**KERR-MCGEE CORPORATION**

Re: Application for an "Other Industrial Waste" Storage Well -  
Sequoyah UF<sub>6</sub> Facility

Response to Oklahoma State Department of Health  
Questions Dated March 23, 1982  
(D. Hensch to W. J. Shelley)

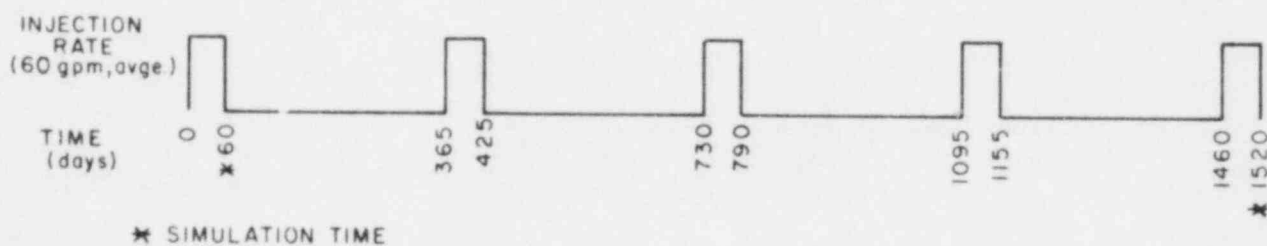
Question 20: What are the main site features?

Response: The attached drawing (Number 290-M-2012) provides a preliminary construction design for pumps and piping at the injection well. A schematic of monitoring equipment was previously supplied in the application (Figure 2 page 9 and Table 1 page 10). Final design drawings are currently under development and will be forwarded when available (in approximately 10 days). However, main site features are not expected to change substantially.

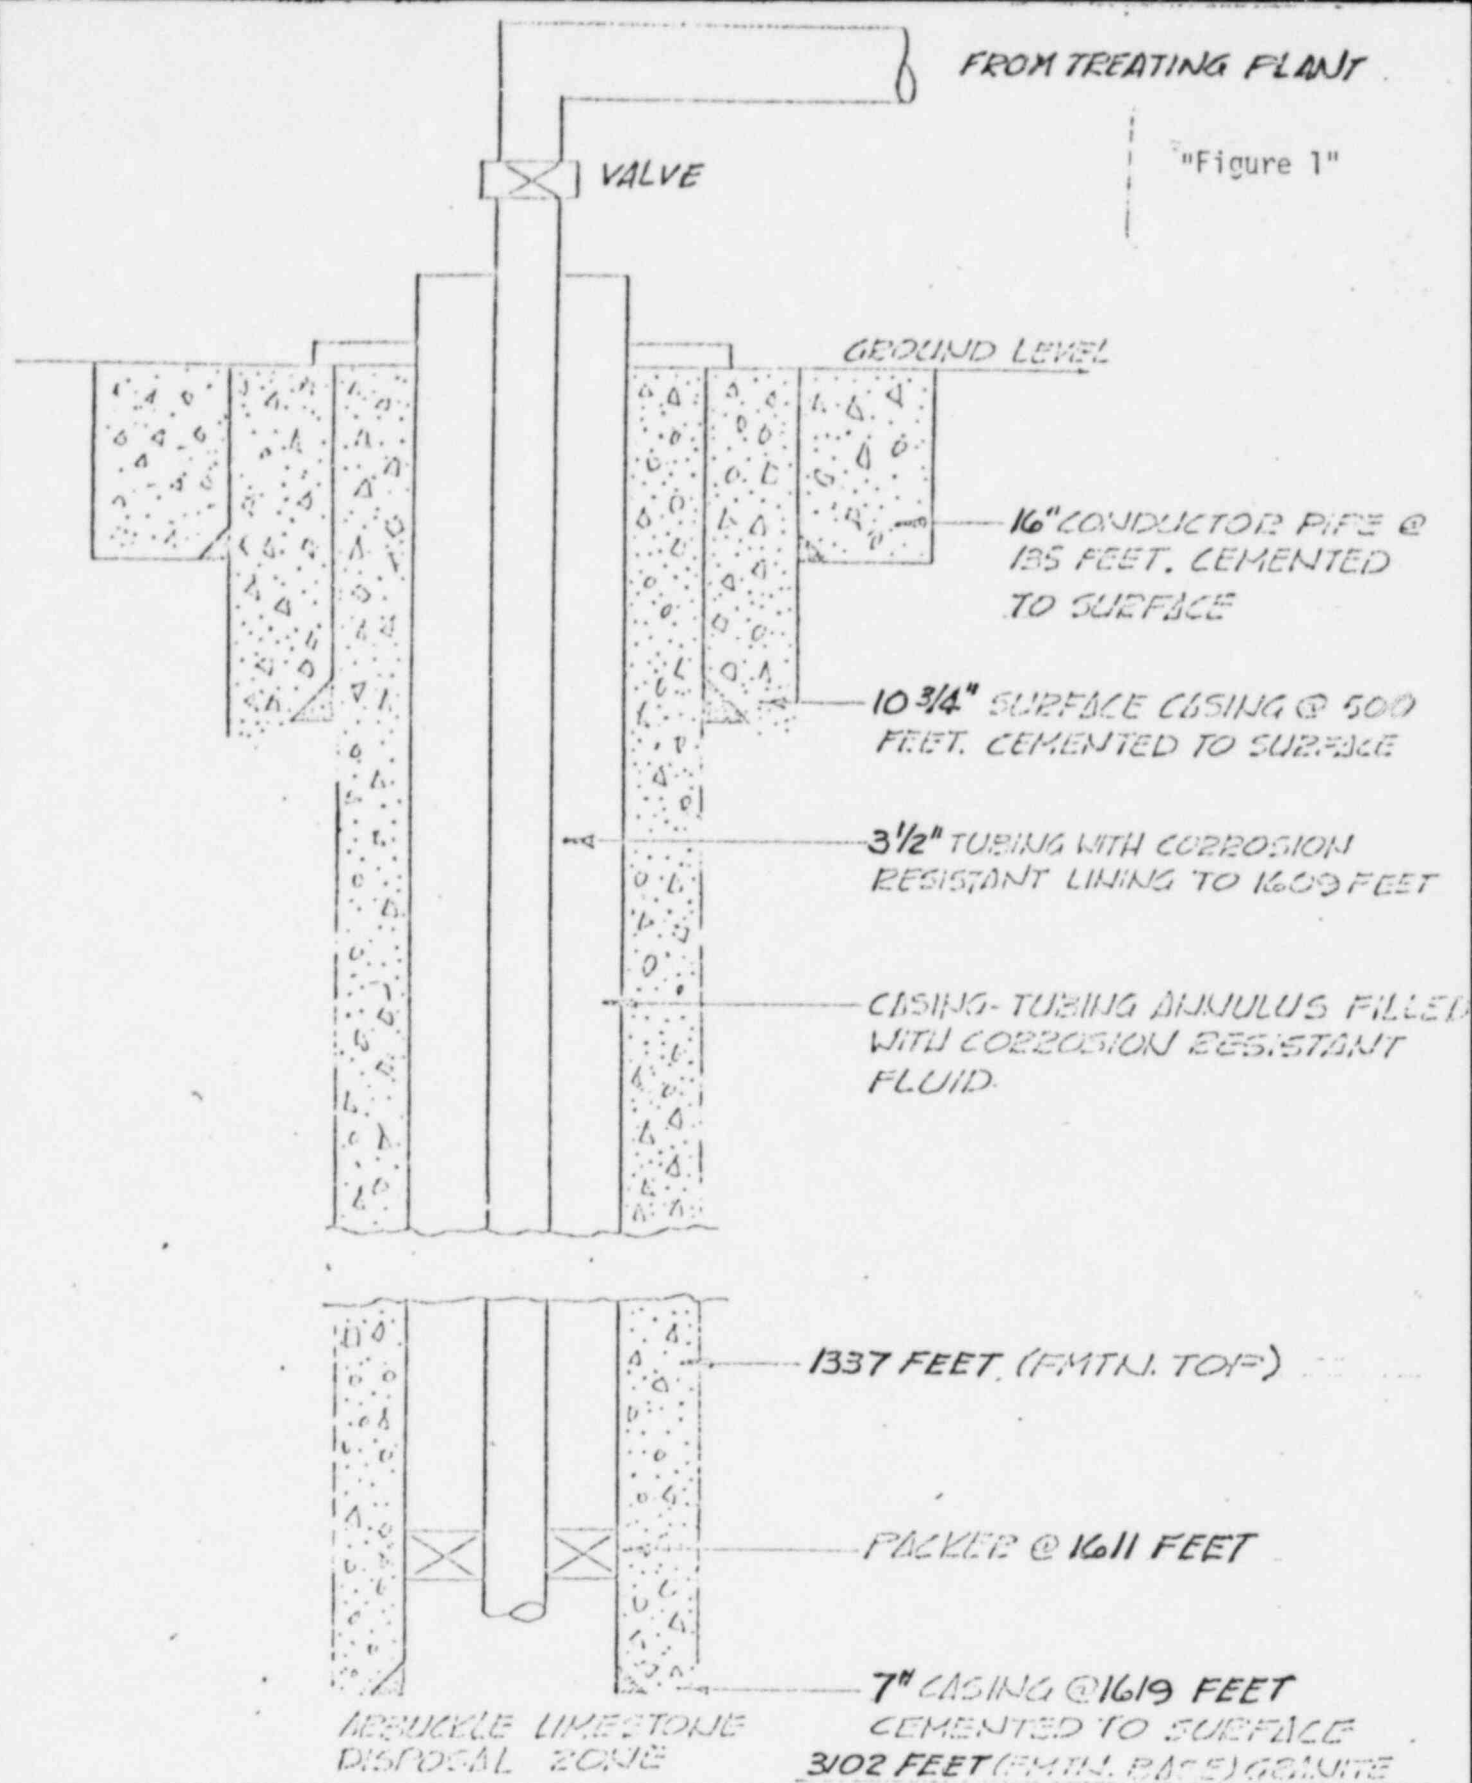
Question 2: A structural map of the Arbuckle.

Response: The attached Figure 1 provides a structural map contoured on the top of the Arbuckle formation in this vicinity and also provides an inventory of oil and gas wells, in the area.

Fig 2.

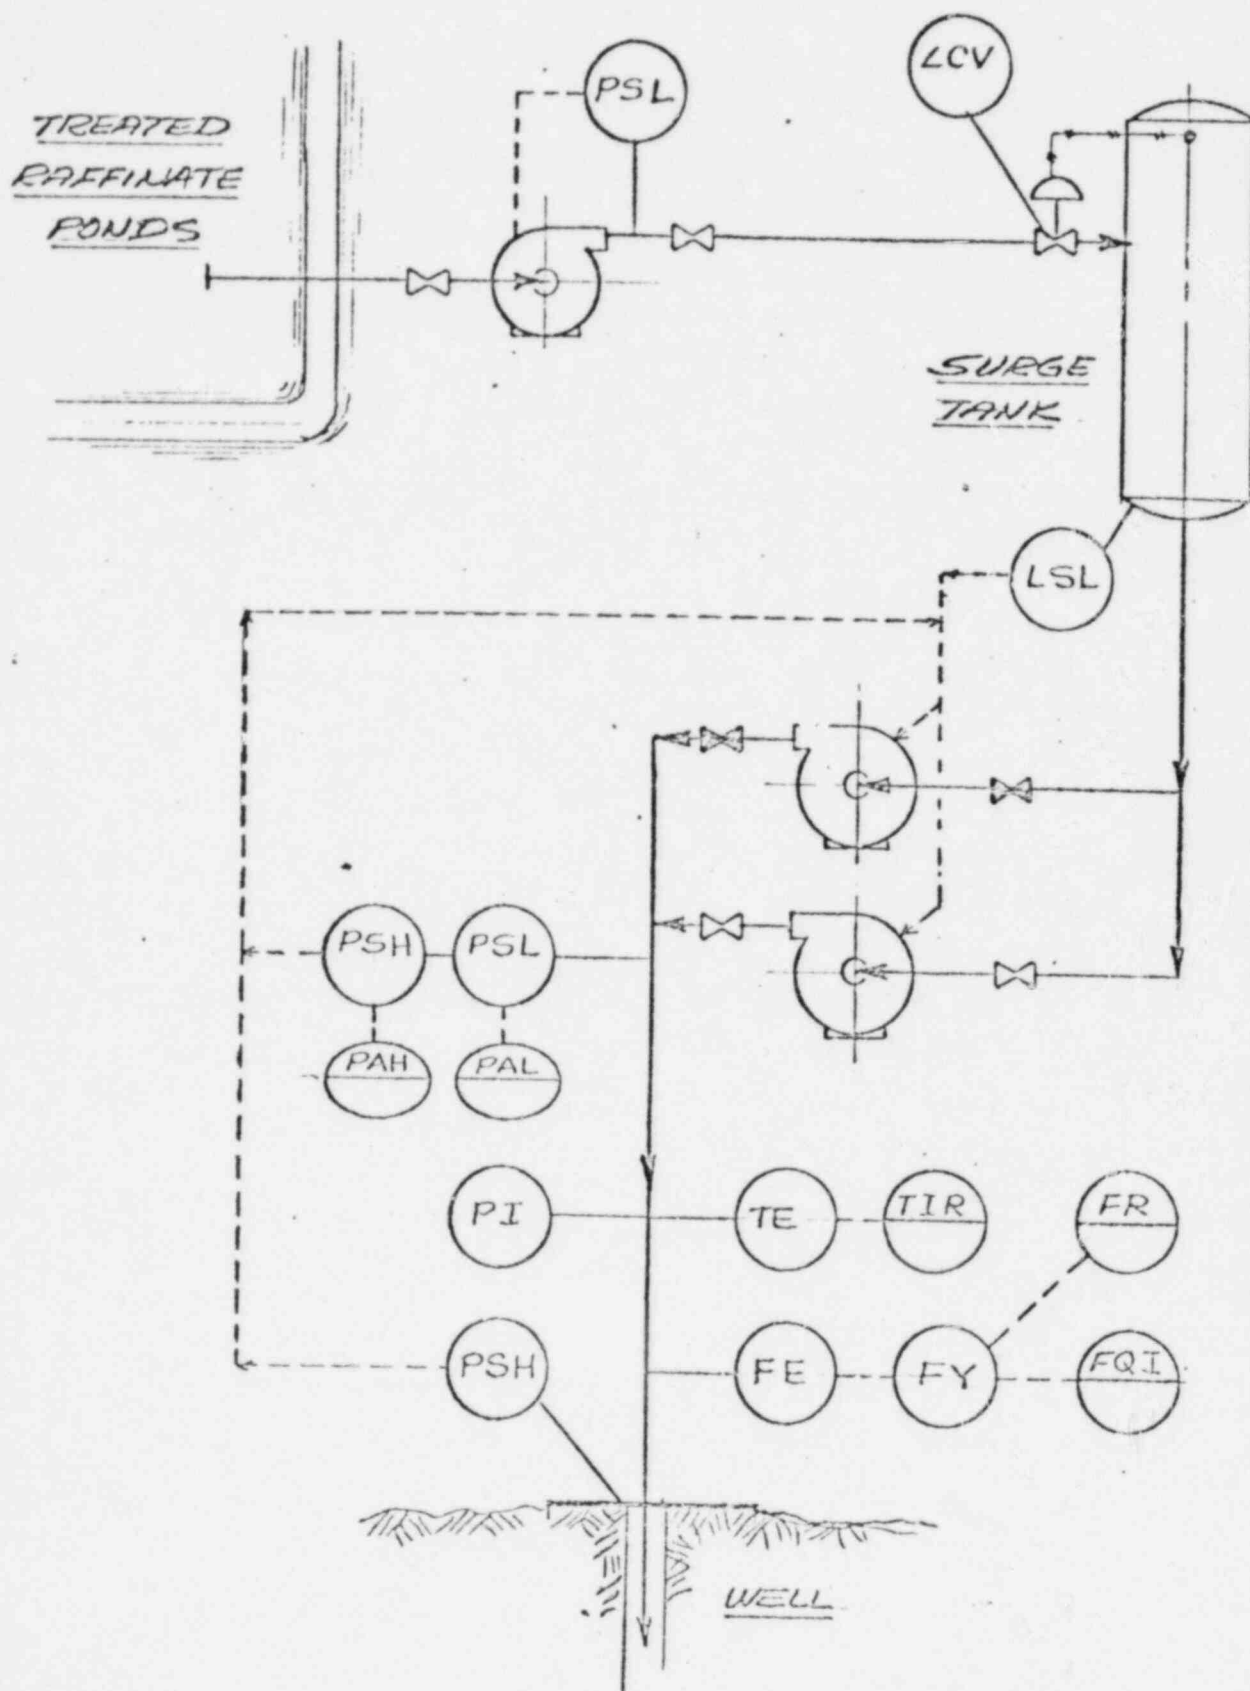
Question 18: Pressure alarms.

Response: As indicated on Figure 2 (schematic) and Table 1, pressure alarms (high and low) will be installed to monitor injection pressures.
